SERVICE**BULLETIN****SB #:** F113**BRANDS:****DATE:** FEBRUARY 2013**TO:** ALL AUTHORIZED FERRIS DEALERS**SUBJECT:** RECOMMENDED DRIVE TENSIONING SPRING UPDATE ON FERRIS IS600Z & IS700Z UNITS**MODELS:** SEE LIST BELOW

Due to inconsistent spring life on IS600Z and IS700Z series zero-turn riding mowers we have issued this bulletin detailing a recommended inspection and correction procedure to update the drive tensioning spring.

Figure 1. Old Style Drive Tensioning Spring (Replace)

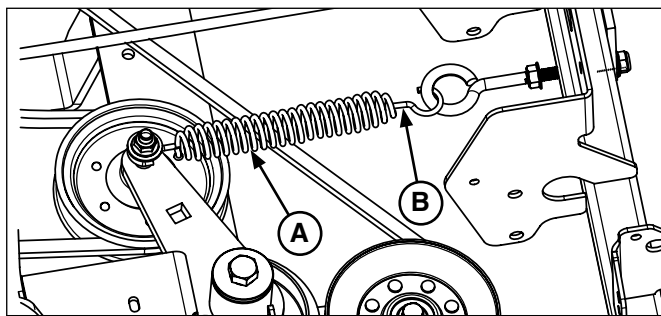
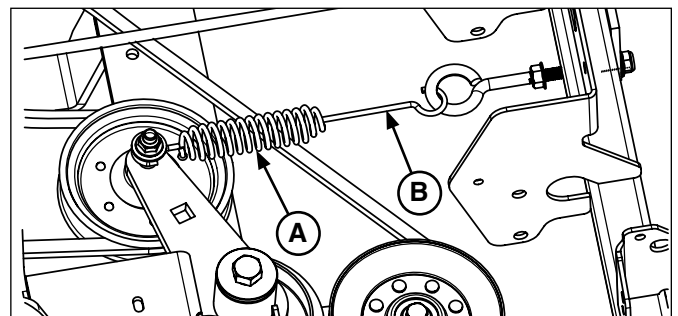
1. Raise the seat plate to gain access to the drive tensioning spring.
2. Visually examine the spring.
 - If the spring (**A**, **Figure 1**) has a short forward hook (**B**) proceed to **Correction Procedure**;
 - If the spring (**A**, **Figure 2**) has a long forward hook (**B**), no action is necessary.

1. Order and install kit # 5600670.
